date November 30, 2017
to Chris Kern, San Francisco Planning Department
from John Davis, Garrett Leidy, and Joyce Hsiao, ESA ACRP CEQA team
subject Alameda Creek Recapture Project (ACRP) EIR Modeling Corrections

Exhibit 1: ACRP EIR (June 2017) Changes due to Model Corrections

Figure 5.16-23

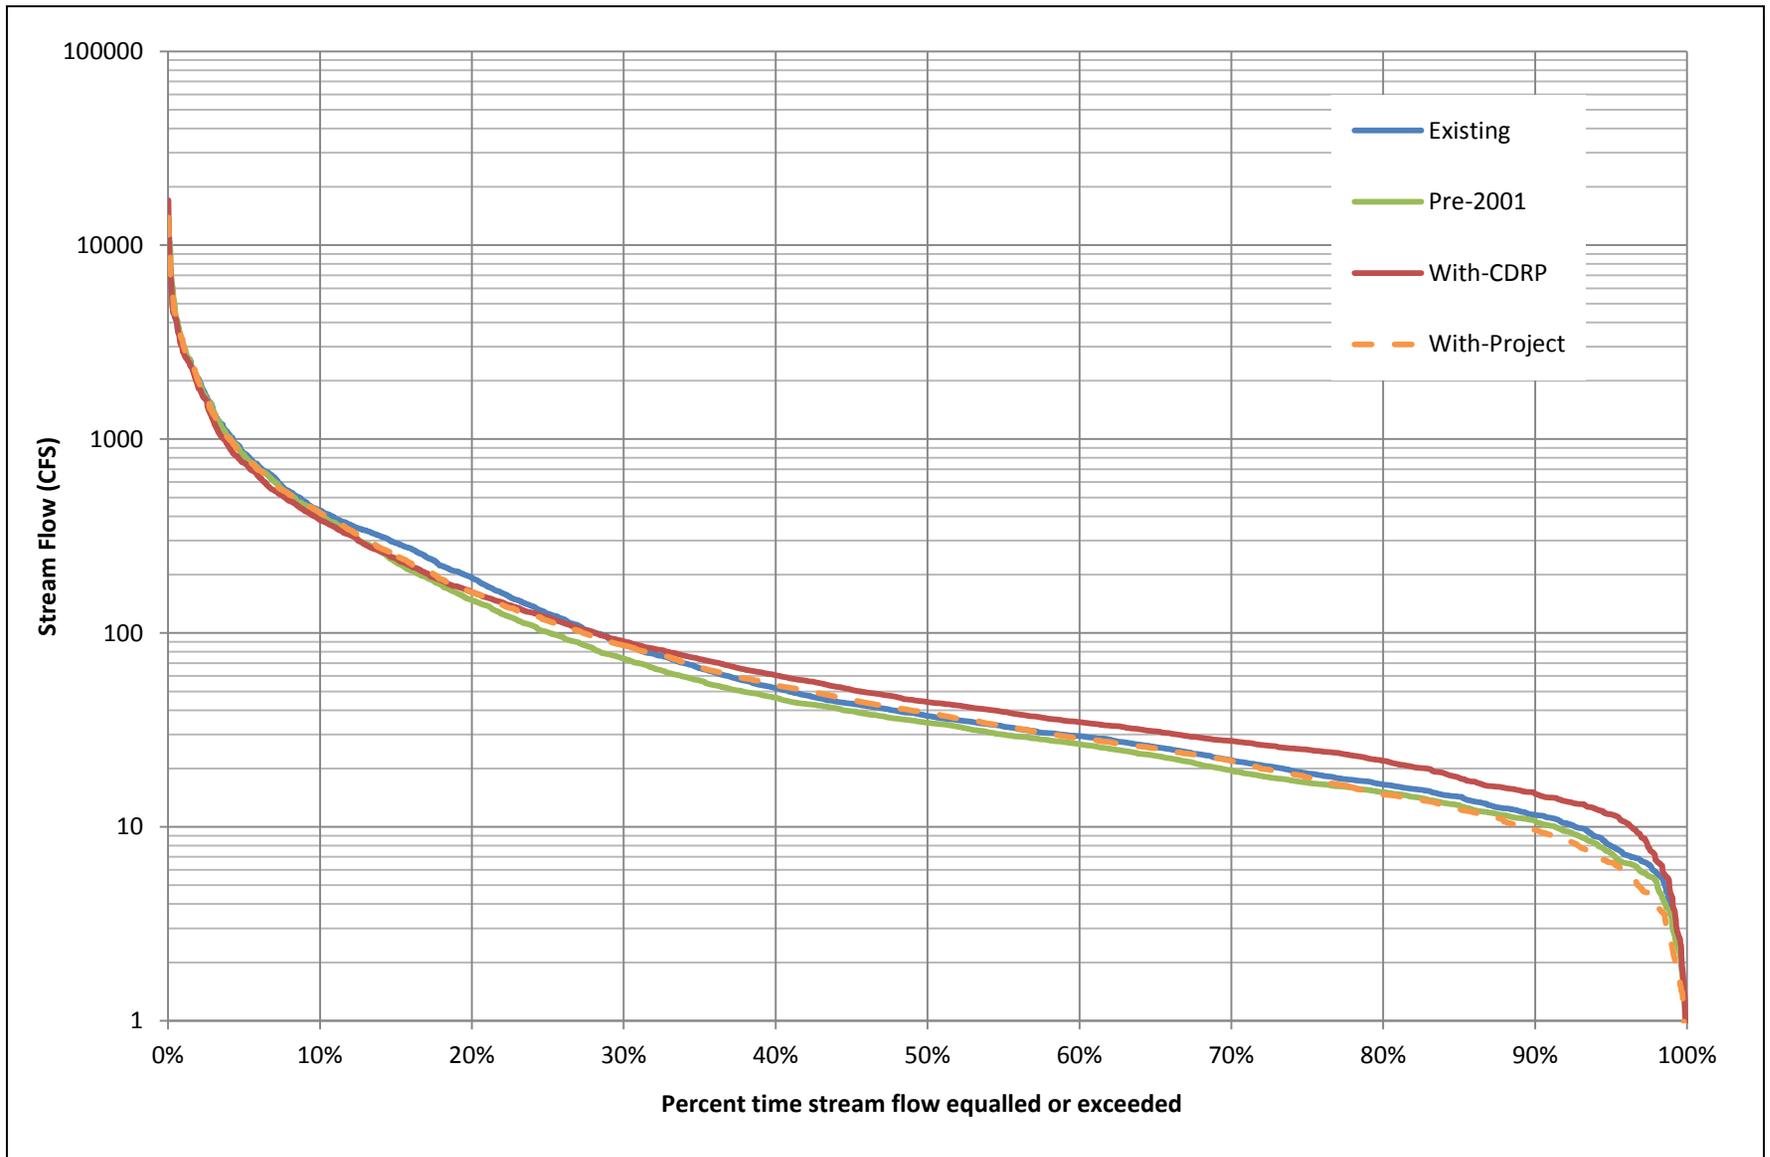
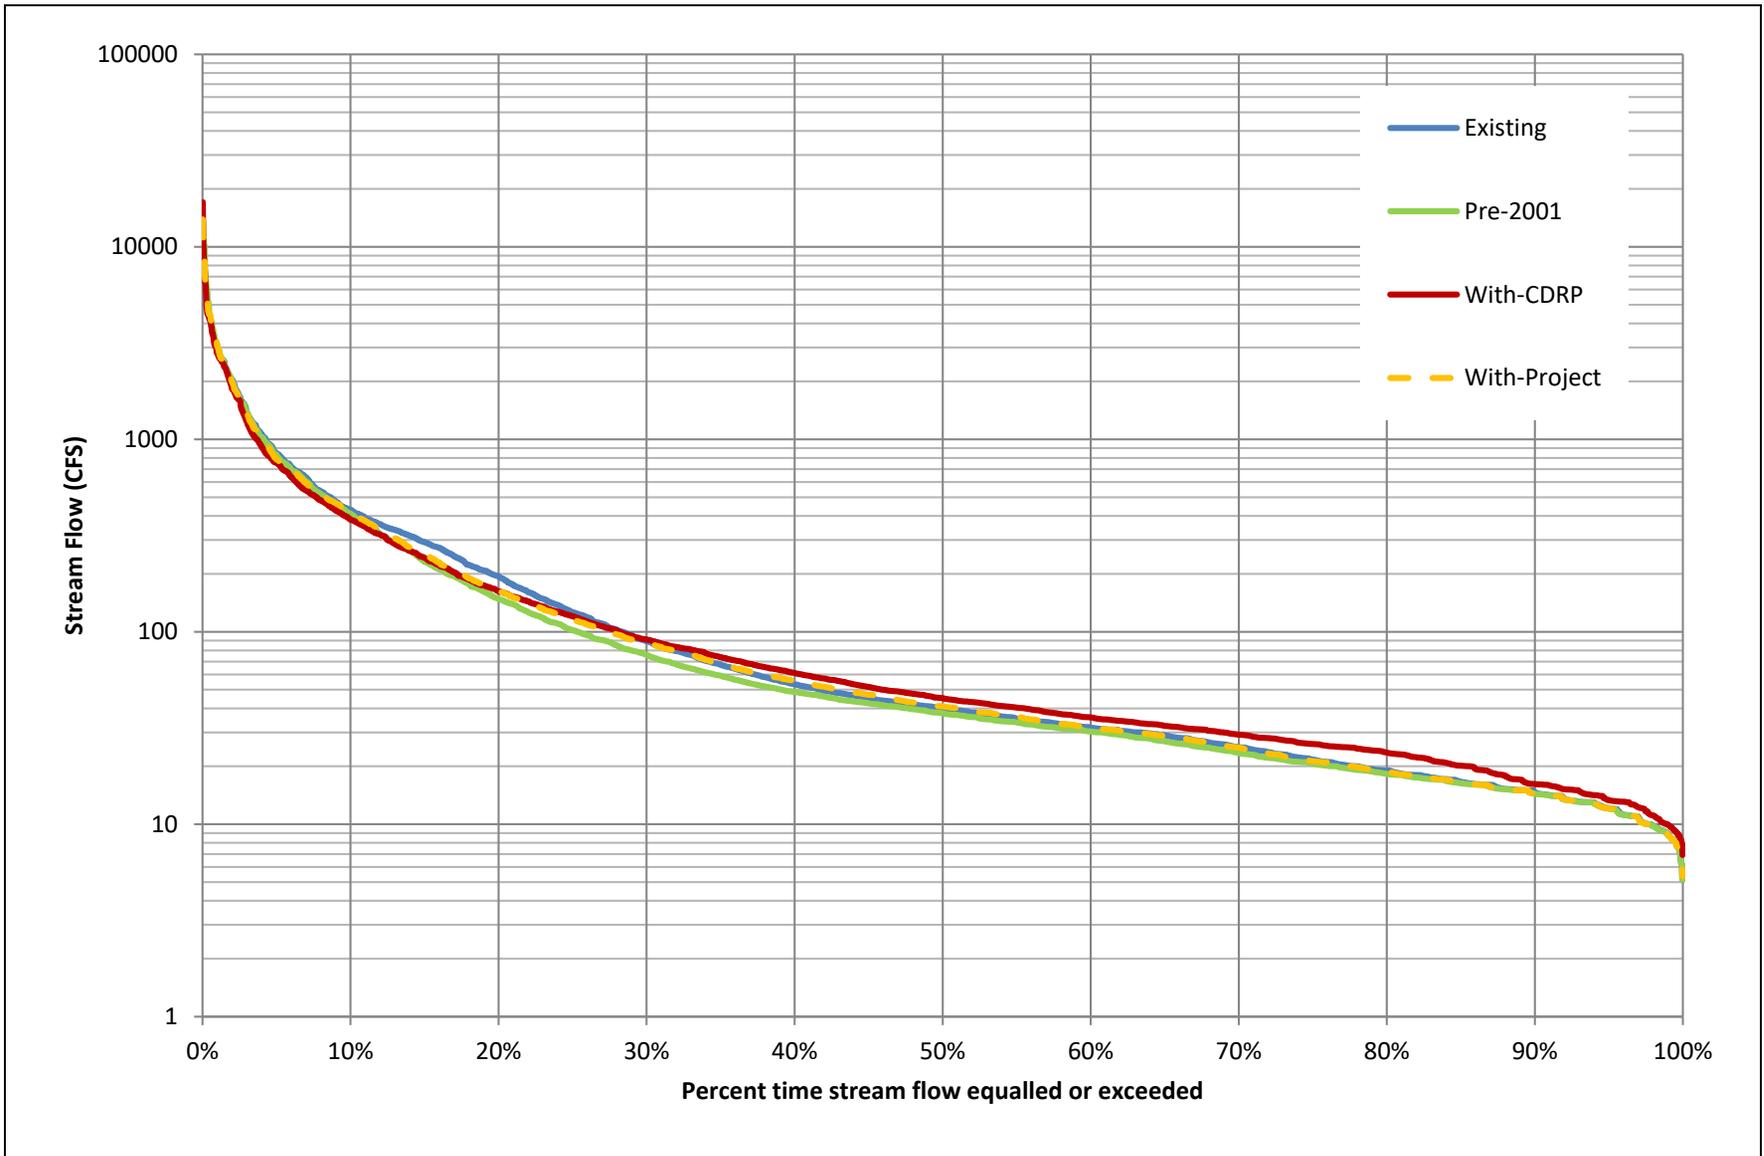
Figure 5.16-23 shows flow-duration curves for Node 9 for the ACWD diversion period (October 1 through May 31) for pre-2001, existing, with-CDRP, and with-project conditions. The corrected Figure 5.16-23R along with the original Figure 5.16-23 are presented in Exhibit 1 for comparison, showing the flow-duration curves for Node 9. Although the values used to plot the curves changed as a result of the correction, the differences between the original Figure 5.16-23 and corrected Figure 5.16-23R are small and not easily seen at the scale of the 8½-inch by 11-inch format.

Appendix HYD1, the surface water hydrology report for the ACRP, is included in the ACRP EIR Volume 2. One figure in Volume 2 is affected by the corrected modeling results, Figure HYD8-1 (page 121). It is identical to Figure 5.16-23 in Volume 1. The corrected Figure HYD8-1R is identical to Figure 5.16-23R, and as described above, the differences between the original and corrected flow-duration curve are minor.

(See revised Figure 5.16.23R compared to the original Figure 5.16-23)

(See above revised Figure 5.16.23R and original Figure 5.16-23, which are identical to Figure HYD8-1R and Figure HYD8-1, respectively.)

Figure 5.16-23R
